Design & Place SEPP EIE

UDIA Response

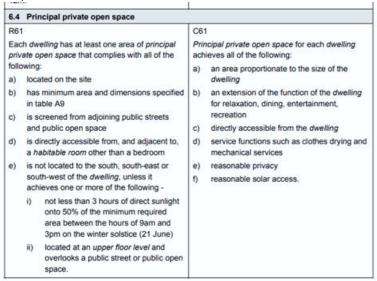
The use of terminology in Figure A2 is concerning. We note:

- 1. "place" is the outcome, not the starting point; the correct term would be "context";
- 2. "Structure", "Grain" and "Form" are all one and the same component. More appropriate headings might be: Context & Country; Land Use Arrangement (housing, employment, retail etc.); Infrastructure; and Implementation.
